IRAQI ARMY FACILITIES
UNDER THE IRAQ SECURITY FORCES FUND
DIYANAH AND DEBECHA, IRAQ

SIGIR PA-07-114
JANUARY 17, 2008

SPECIAL INSPECTOR GENERAL FOR IRAQ RECONSTRUCTION

SUBJECT: Report on Construction and Renovation of Iraqi Army Facilities at Diyanah and Debecha, Iraq (Project Number SIGIR PA-07-114)

Site Photo 6. Typical building exterior before renovation at Diyanah.
(Photo courtesy of Toltest)

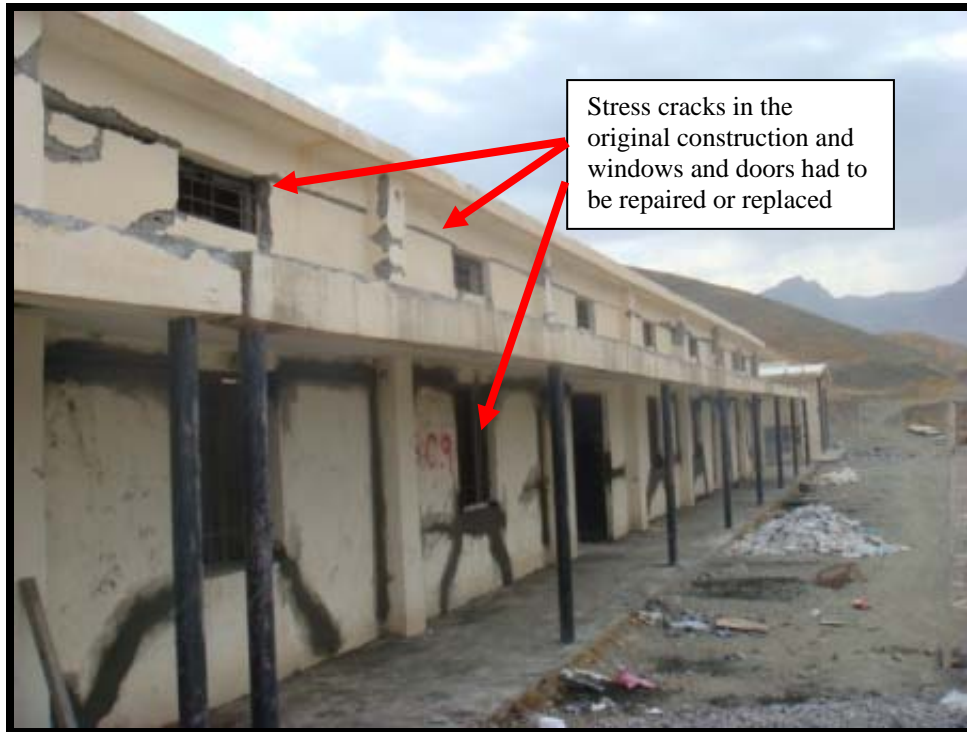
Site Photo 6 shows the “typical” exterior of buildings found to be structurally sound, but in disrepair before renovation at Diyanah.

Site Photo 9. Renovation included replacing poorly designed original expansion joints that leaked.

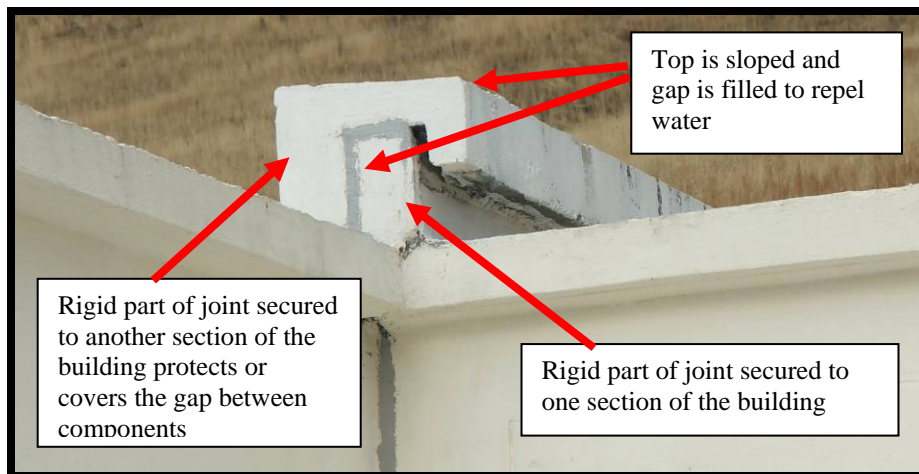
Site Photo 9 shows an expansion joint after renovation. The design of the expansion joint and application of a sealer between the building sections should ensure a water tight joint.

Site Photo 10. Typical building exterior following renovation. (Photo courtesy of Toltest)

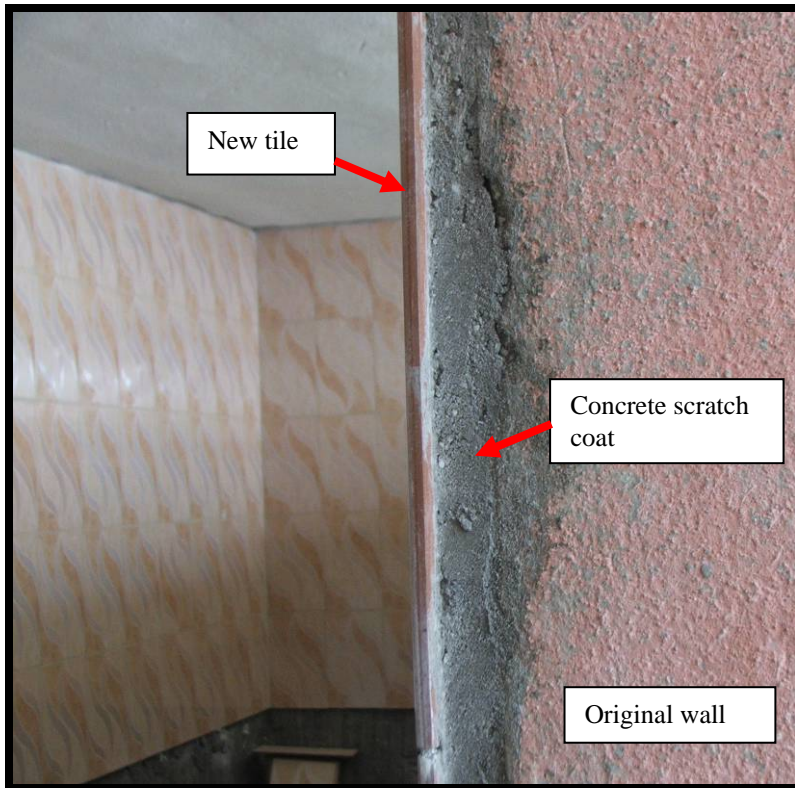
Site Photo 10 is representative of buildings following renovation including exterior painting. Substantial repair work preceded the final exterior painting process. Site Photo 11 shows where workers repaired cracks and removed loose exterior plaster/stucco. Large sections of damaged or loose stucco were replaced with new plaster/stucco in preparation of exterior painting. Patch work over cracks and flat surfaces was covered with wire mesh to ensure bonding between the original wall and the fresh plaster/stucco.

Site Photo 15. String at proper height with square corners will guide block layers.

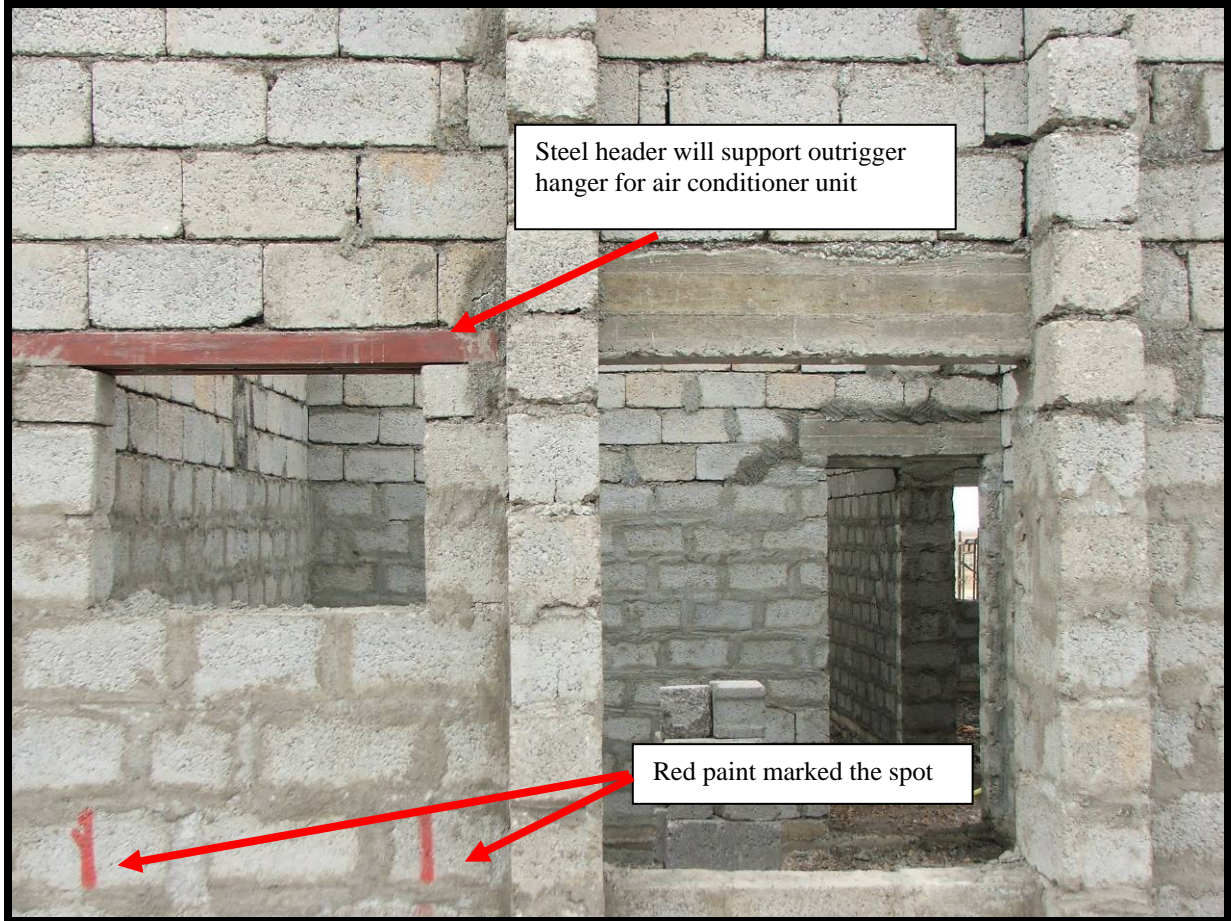
At the Debecha site, the subcontractor laid the first course of concrete blocks to ensure a square cornered building with level blocks placed at correct elevations. Specifically, string was used to show the line that block layers will use to guide the placement of concrete blocks. Using the string as a guide ensures corners are square, blocks are placed level and at the correct elevation (height), and blocks are placed in a straight line. Site Photo 15 shows the layout and string for the hand washing area outside the dining facility while Site Photo 16 shows a transit used to ensure correct elevations.
